# 16VARIANCE 1054 11820 Ransum Drive

Louisville Metro Board of Zoning Adjustment
Public Hearing

Laura Mattingly, Planner I
August 15, 2016

#### Site Plan

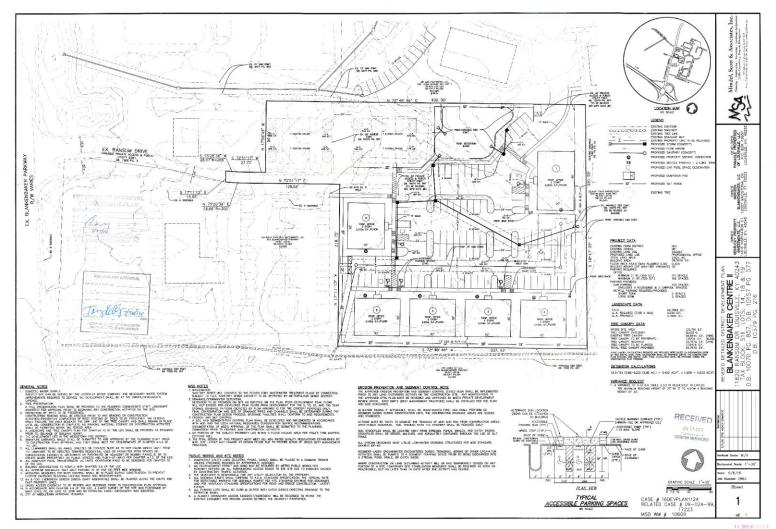
• Although it is possible to build offices on this site that are in compliance with the LDC, the variance request is reasonable and does not appear to adversely impact public health or cause a nuisance and is compatible with surrounding development, therefore the variance appears to be adequately justified and meets the standard of review.
